ENTITLED: "A RESOLUTION AUTHORIZING THE MAYOR AND THE CITY CLERK TO SIGN A FINAL PLAT FOR STANFIELD ADDITION, 5TH FILING, A REPLAT OF LOTS 4-6, BLOCK 693, STANFIELD ADDITION AND LOTS 1-3, BLOCK 694, STANFIELD ADDITION, SECOND FILING, AND ALL OF THOSE REMAINING PORTIONS OF LOTS 4 AND 5, STANFIELD ADDITION, SECOND FILING, CHEYENNE, LARAMIE COUNTY, WYOMING (LOCATED AT THE SOUTHEAST CORNER OF THE INTERSECTION OF STANFIELD AVENUE AND W. 5TH STREET)."

Stanfield Addition, 5th Filing Expedited Preliminary Plat

CASE NUMBER(s): UDC-20-00175

Stanfield Addition, 5th Filing **Expedited Preliminary Plat**

PRELIMINARY PLAT

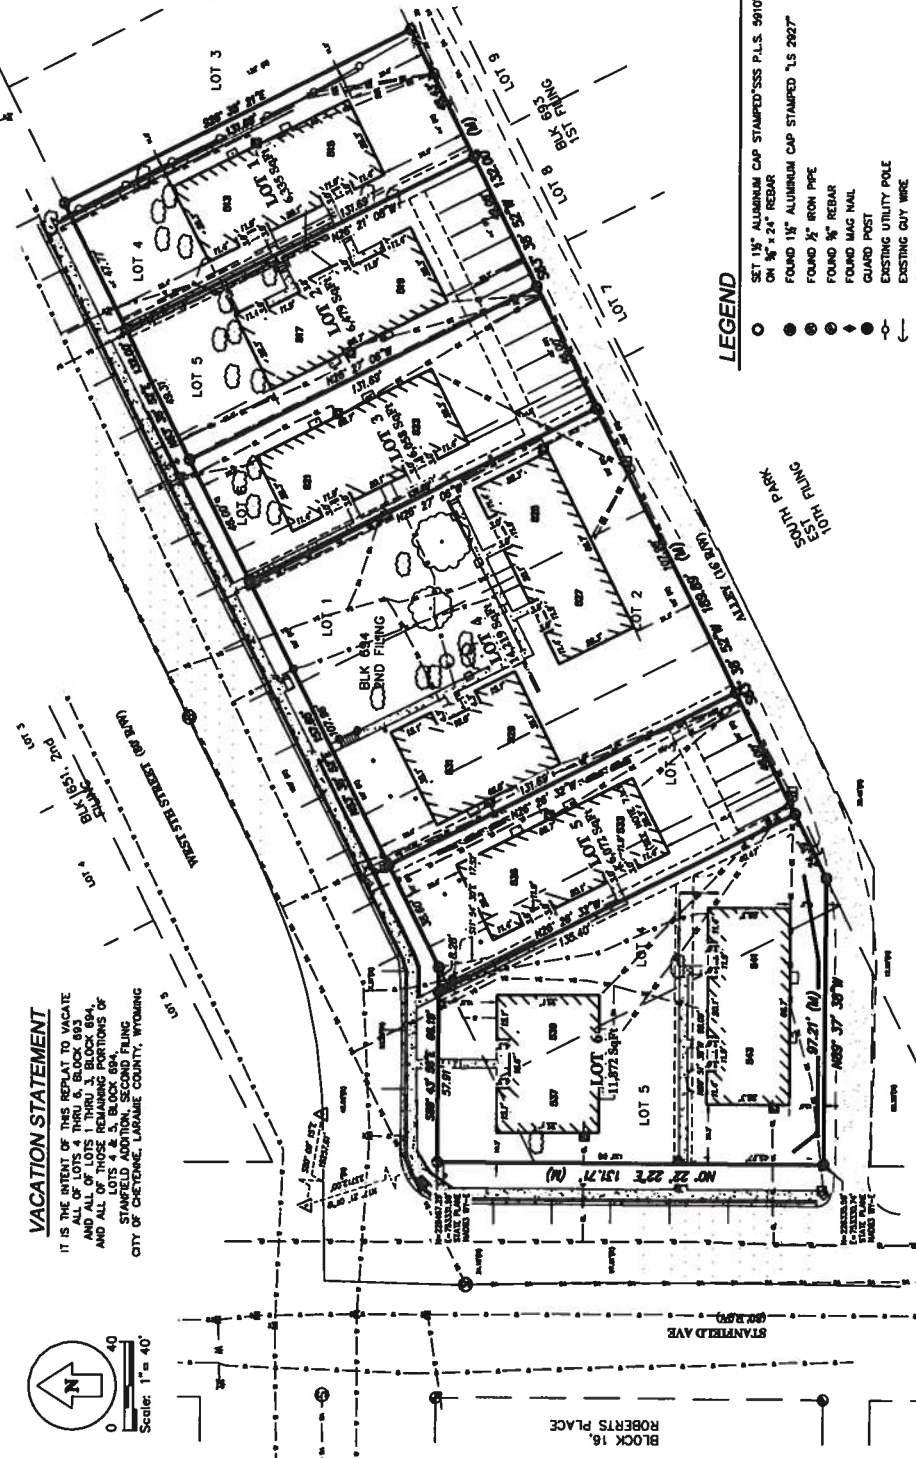
- **(FYI)** Note that lots are not divisible until proper individual BOPU service lines are installed. Until installation, Northland Holdings LLC will be required to enter into a common water and sewer service connection agreement with the Board of Public Utilities for all of Block 1 Lots 1-6.

- **(FYI)** Lots 1, 2, 3, and 5 are proposed SD3 lots. These lots do not meet frontage or setbacks. Variance to these deficiencies (UDC-19-00618) approved November 21, 2019.

- **(FYI)** Lots 4 and 6 are proposed MD2 lots. Existing structures on these lots do not meet setbacks or frontage. Variance to these deficiencies (UDC-19-00618) approved November 21, 2019.

- **(FYI)** Plat largely appears to meet all review criteria and eligibility for an expedited plat.
- **(Fulfilled by revised submittal)** Where are the access locations? 5th Street is a collector thus requires 75 foot of access spacing and the alley is only 16 feet wide. Can you clarify how you will handle access locations?

- **(Fulfilled by revised submittal)** Note 8 must added to the final plat as well so that no accesses will be allowed off W. 5th Street.

- VEHICULAR ACCESS TO ALL LOTS AND PARKING AREAS CONTAINED WITHIN THE BOUNDARY OF THIS PLAT ARE LIMITED TO THE PLATED AND CONSTRUCTED 16' PUBLIC ALLEY R/W ABUTTING THE SOUTH BOUNDARY OF THIS PLAT.
